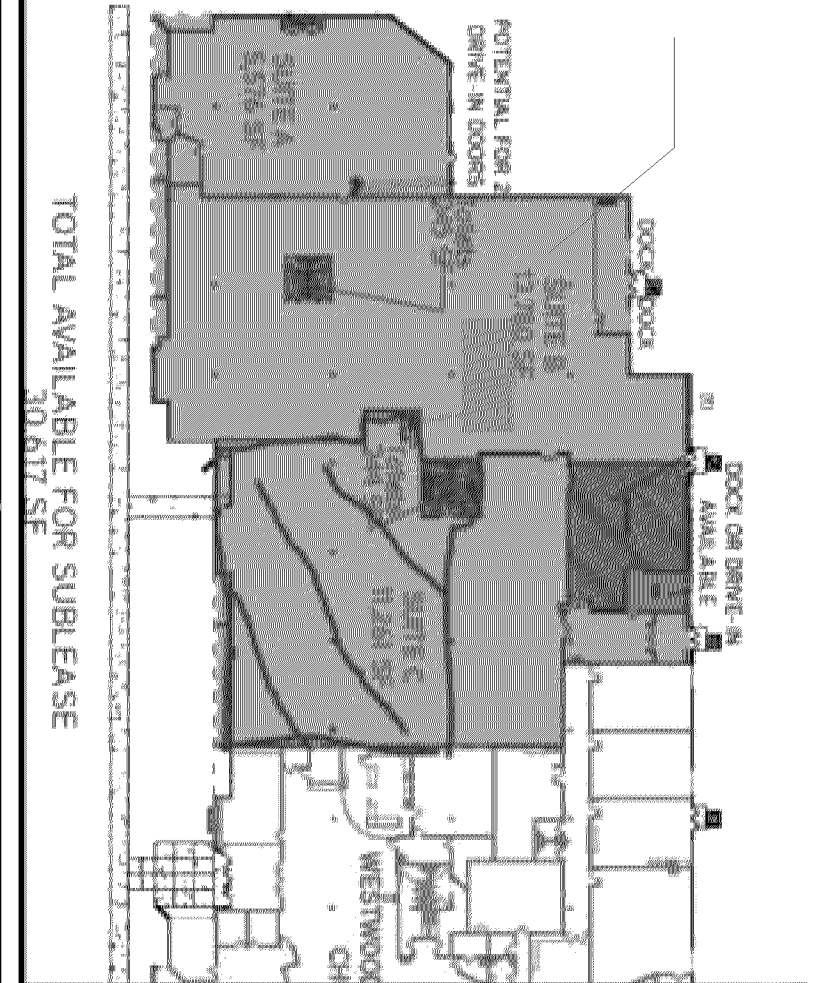
According to applicant, Suite B is 13,780 sq ft. Plan is not clear.
